# Imray Correction Notice IC2800-3

## Chart 2800 WGS 84

*Edition 2021*

*Below is a complete list of corrections issued since the 2021 edition of this chart was published.*

Block correction for 2800 Tidal streams  
around the north of Jura  
ILNW 184/22

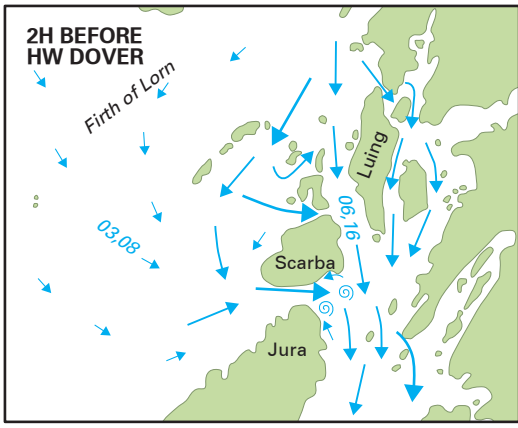
#### 3 Tidal streams around the north of Jura (*certain copies*)

Insert block correction tidal stream diagram around Jura 2H Before HW Dover replacing the duplicate 1H Before HW Dover diagram (ILNW 184/22)
